Plan 22 AUG 2003 Ref 1039/03

PROJECT
Proposed office revision to front of warehouse (earlier approved office & warehouse application Planning ref. H16/0583/02 & Building Regs. ref B16/75902)

DETAILS
Elevations / Section

DRG No. 047/1/2003[B]

Front Elevation

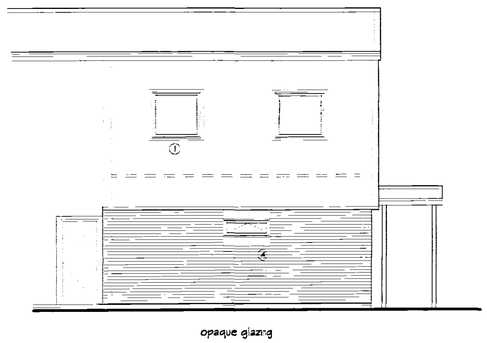
B	Facing bwk. colour added to comply with Planning Condition 2 (to match ex. canteen bwk. as near as possible) but not coloured mortar	mjw 21/08/03
A	Front entrance door side panels removed to suit Peter Eaton fax dated20/8/03	mjw 20/08/03

Principal Entrance Door (Double Leaf) glazed each leaf to have min. 810mm clear opening width c/w glazed side panels,all to give zone of visibility from 900mm to 1500mm from ffl wherever the opening action of the door could constitute a hazard.Unobstructed space on the leading edge (non hinge side) of @ least 300mm, unless door opened by suitable automatic control. Door entrance cill to be aluminium not upvc all to conform with part 'M' of the Building Regs. (max. 15mm step)

B FACING BRICKWORK :
All elevations to ground floor offices only facing bwk. to match nearby existing canteen bwk. type & colour as near as possible (not coloured mortar) c/w soldier arching & blue engineering bwk. dpc
